DUFRESNE GROUP CONSULTING ENGINEERS

Re: Concerns regarding a Proposed Marina near the Water Treatment Facility
DG: 4150008

We are pleased to submit this engineering report addressing City concerns regarding a proposed marina project adjacent to the Water Treatment Plant at 234 Penny Lane. This report is based on the May 18, 2015 request for technical assistance.

FIGURE 4
LIQUID OXYGEN STORAGE TANK
SCHEMATIC PLAN

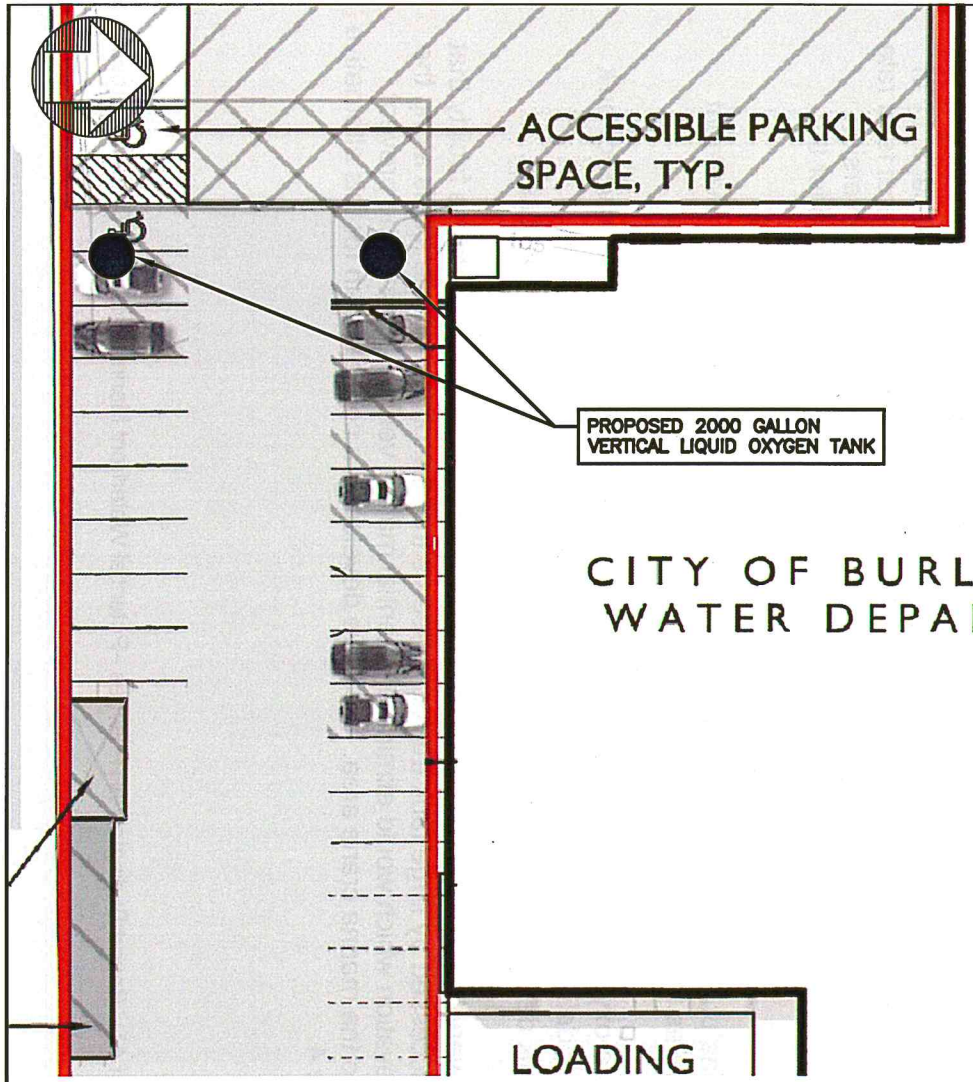
An ozone generator system would be required to manufacture ozone from the pure oxygen for use at the facility. This generator would have a significant electrical load that would likely require modifications and upgrades to the primary electrical service, standby generators, a transfer switch, and distribution wiring.

There is very little land available for storage of liquid oxygen adjacent to the facility that can be accessed by large tank trucks. It seems that the only available site is along the south elevation which would eliminate potential marina vehicle parking and prevent access to the marina crane area. We have developed a concept plan for this alternative in Figure 4.
